Docket Item # 5 & 6
BAR CASE # 2012-0404 &
2012-0405

BAR Meeting
January 16, 2013

ISSUE: Permit to Demolish &
Certificate of Appropriateness

LOCATION: 1107 Duke Street

1 FRONT EXTERIOR ELEVATION
SCALE: 1/4" = 1'-0"

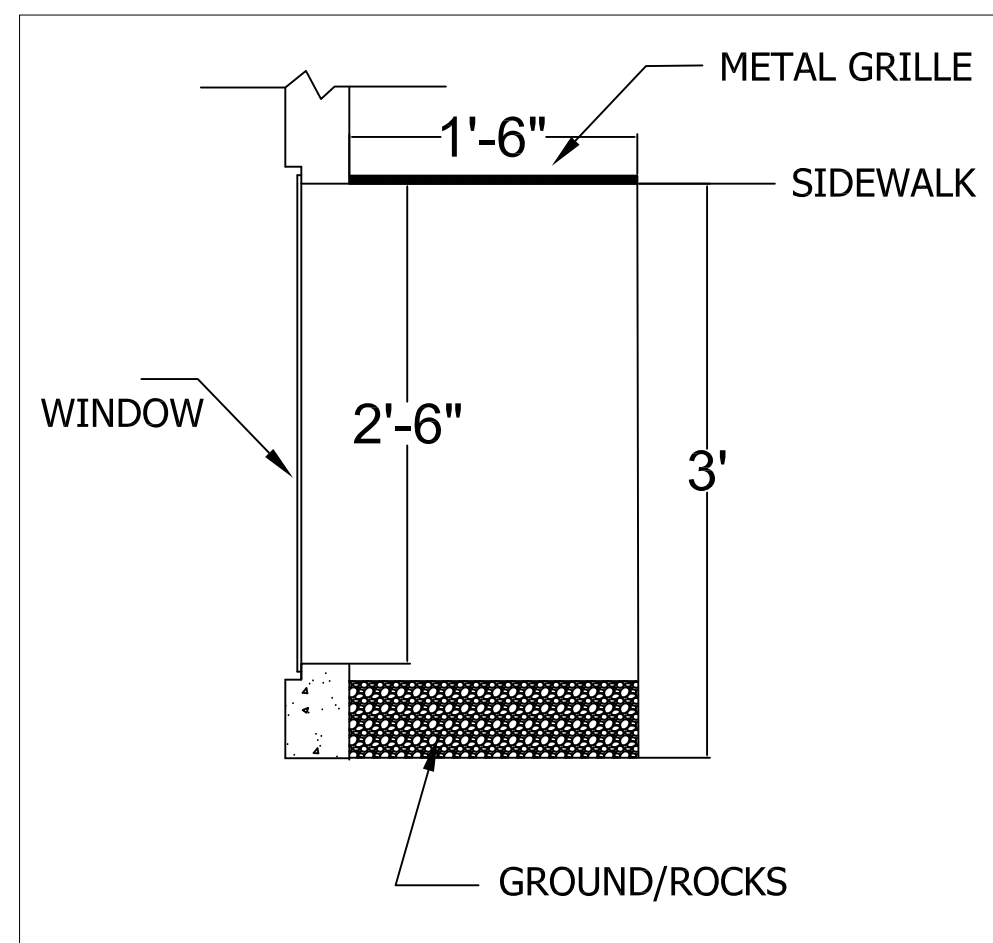
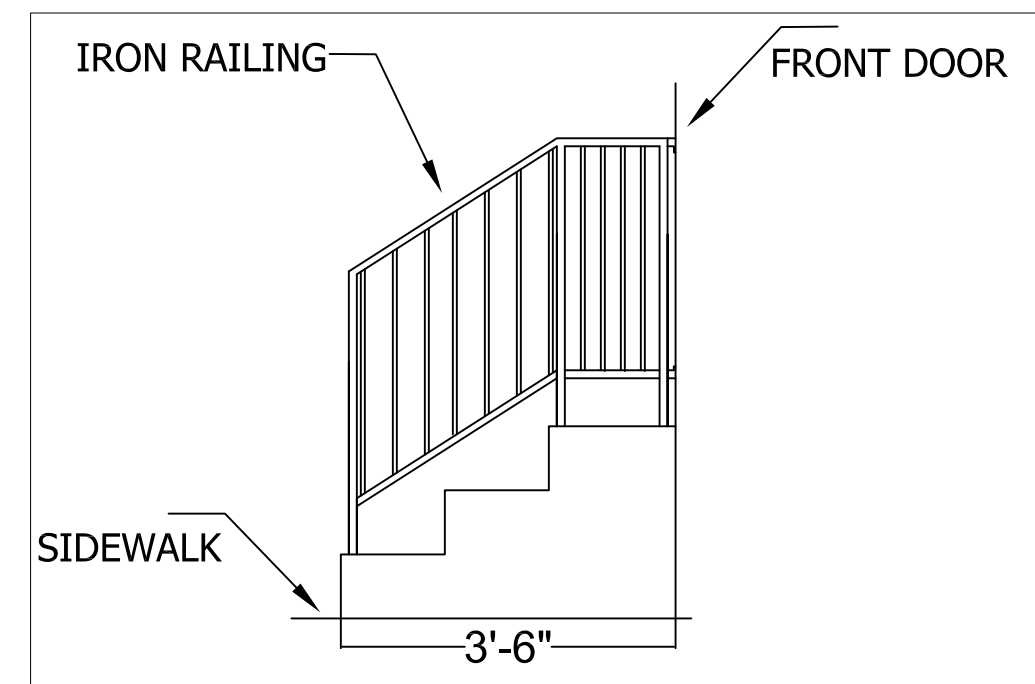
Staff supports the demolition of the front planter and the re-opening and restoration of the basement window on the front elevation. The planter is likely a 20th century alteration and its removal, combined with the reopening of the basement window, is an encouraged and historically appropriate alteration. It is evident that the house was likely constructed with a paired basement window without the existing planter, as the segmented brick arch and mullion still remain and the infill brick is noticeably different in texture than the surrounding masonry. However, the window should be historically appropriate in its dimensions and proportions.

The applicant is requesting to install a pair of one-over-one double-hung basement windows which is not a traditional basement window type. Due to the window's at- and below-grade location, the applicant also requests approval to install fiberglass windows. Staff recommends that the applicant install two wood basement windows, either casement, hopper, or awning in operation, as opposed to the proposed double hung windows. Staff cannot support a fiberglass window in this highly visible location on the front elevation due to the age of the building. Staff recommends that the applicant submit revised window specifications for the basement window for a more stylistically and materially appropriate window for staff approval before installation.

The proposed window well complies with Zoning, if the window well projects into the public right-of-way, the applicant must apply for an encroachment. Staff has no objection to the proposed window well as window wells are a common feature within Alexandria's historic districts. However, the applicant will need to submit specifications to Staff for the proposed metal grate prior to installation.

The proposed painted wood two-over-two, simulated divided light sash replacements for the remaining openings nearly meet the criteria set forth in the Board of Architectural Review *Window Policy* and will greatly enhance the historic character of the building. With a few minor changes, Staff could approve the replacement windows administratively. For example it is noted that the windows must be sash replacement kits or full-frame replacements and not insert windows. The muntins will need to have a putty glazed profile as opposed to the proposed ovolo style. It is Staff's preference and recommendation that all historic window trim and frames should be retained. The applicant should work with Staff on the details of the frame and muntins for the proposed windows before final approval.

The proposed four-panel wood door is historically appropriate and meets the requirements set forth in the Board's adopted *Policies for Minor Architectural Elements*. The proposed railing does not meet the aforementioned policy. The proposed railing should be simplistic in design and detract as minimally as possible from the prevailing Victorian style of the building. Therefore Staff recommends that the railing design have no balustrade.

The proposed light fixtures are appropriate in scale and material. Staff has no objection to the installation of a gas lamp in place of the existing electric light on the front elevation.

1. That the applicant submit revised window specifications in conformance with the BAR's adopted *Window Policy* for the proposed windows on the south elevation prior to issuance of a building permit;
2. That the proposed railing for the front stoop be a simple metal railing with no pickets; and
3. That final approval of the proposed metal grate be approved by BAR staff prior to issuance of a building permit.

1 REAR EXTERIOR ELEVATION
SCALE: 1/4" = 1'-0"

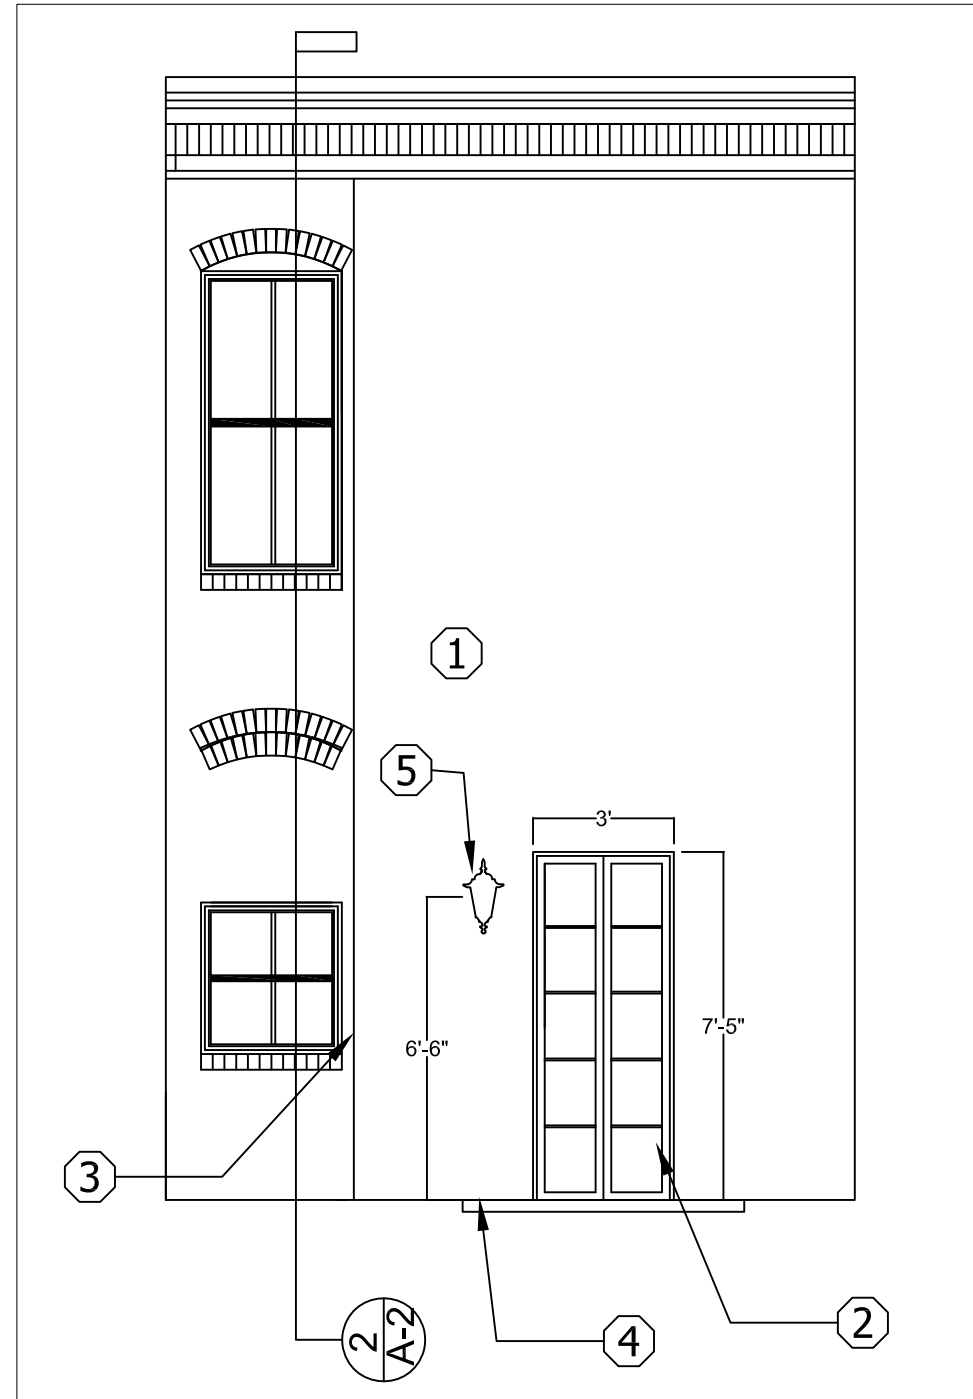
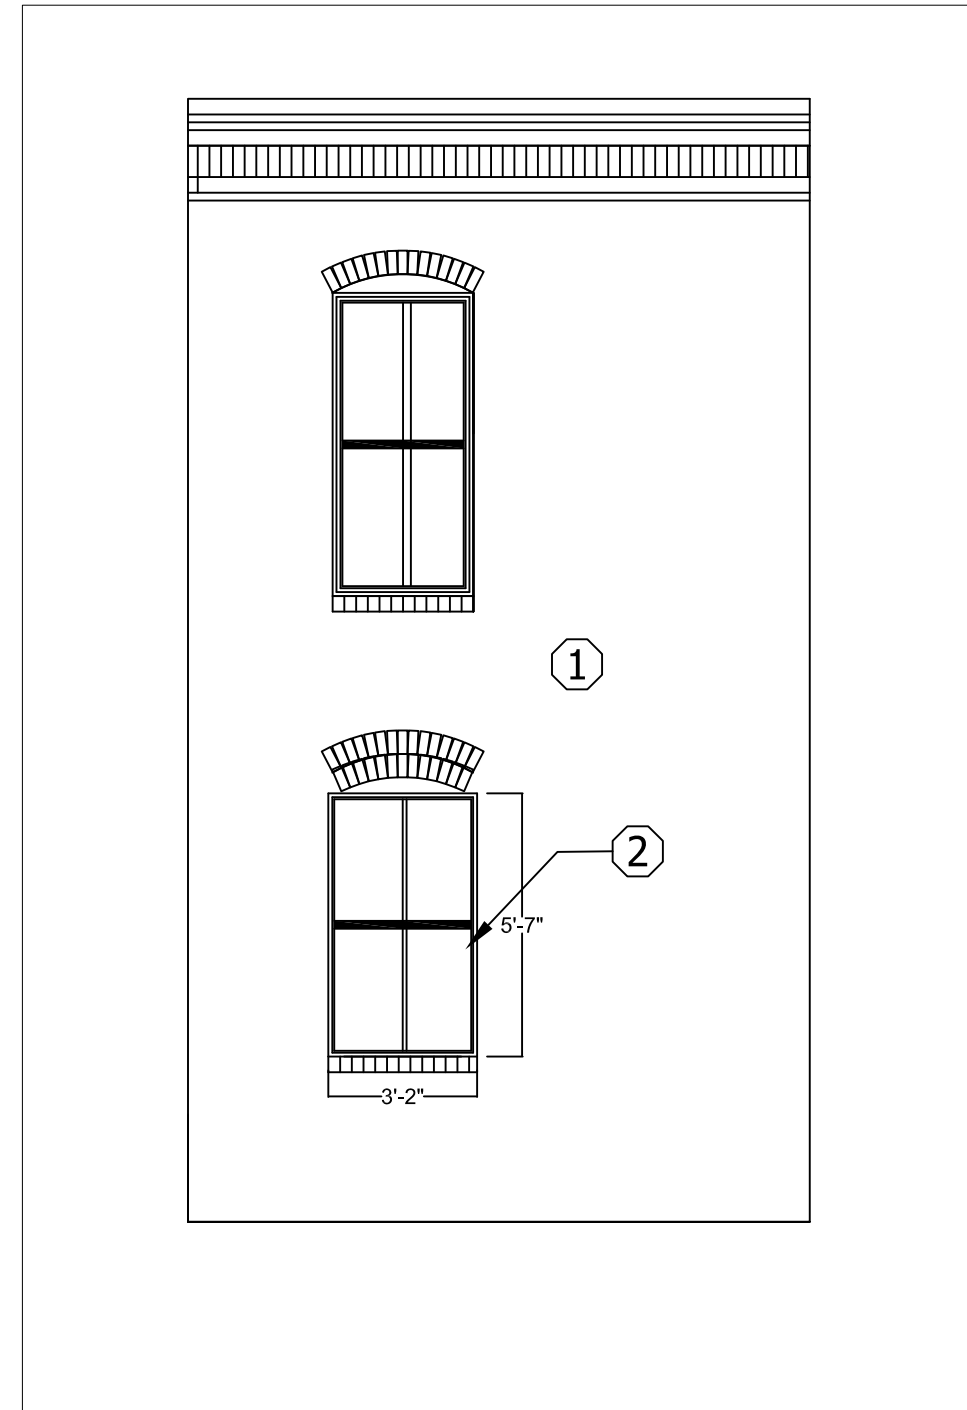
The north elevation does not have the same level of integrity as the front elevation. On the north elevation of the rear ell, two second story windows have been removed and replaced with brick, discernible by the disruption in the seven-course common bond brick pattern, and the first story window on this elevation has been considerably reduced in size. Remaining windows have been replaced with six-over-six vinyl windows. Staff fully supports the applicant's proposal to replace the historically inappropriate vinyl windows with wood simulated divided light two-over-two windows, as this complies with the adopted *BAR Window Policy*. The historic window frames should be retained where possible.

Staff has no objections to the design of the French doors, proposed Bevolo electric light fixture, or proposed rear at-grade wood deck as these elements are minimally, or not at all, visible due to an existing rear-yard fence.

The replacement of an existing door and transom on the east elevation of the rear ell with a window is also supported by Staff. The opening may be original to the building however the existing door is not. There have been numerous alterations to openings on the rear ell over time that have lessened its integrity. Staff notes that this change is minimally visible from a public right-of-way and is a common alteration to rear ells as buildings are adapted for modern use.
